TRANS/WP.29/536 30 April 1997

DRAFT SUPPLEMENT 4 TO THE 02 SERIES OF AMENDMENTS

TO REGULATION No. 3

(Retro-reflecting devices)

Figure 1

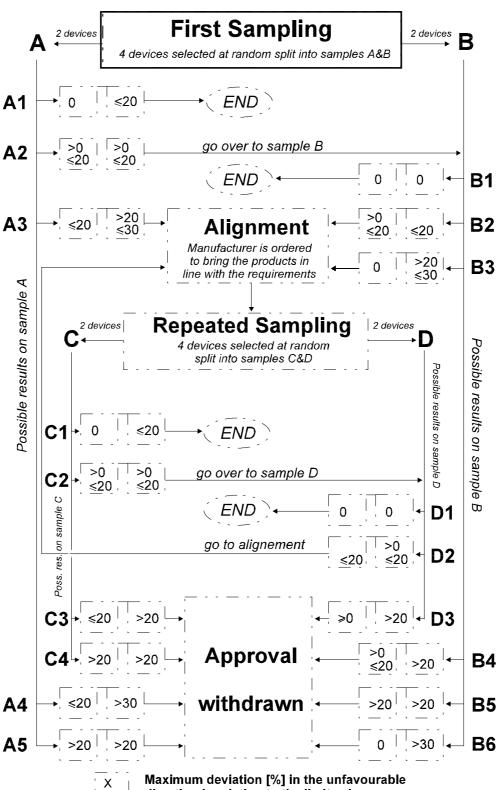
2.1.1. Following the sampling procedure shown in Figure 1 of this annex the conformity of mass-produced retro-reflectors shall not be contested if the deviation of the measured values of the retro-reflectors in the unfavourable directions are:

2.2.1. Following the sampling procedure shown in Figure 1 of this annex the conformity of mass-produced retro-reflectors shall be contested and the manufacturer requested to make his production meet the requirements (alignment) if the deviations of the measured values of the retro-reflectors are:

Conformity shall be contested and paragraph 9 applied if, following the sampling procedure in Figure 1 of this annex, the deviations of the measured values of the retro-reflectors are:
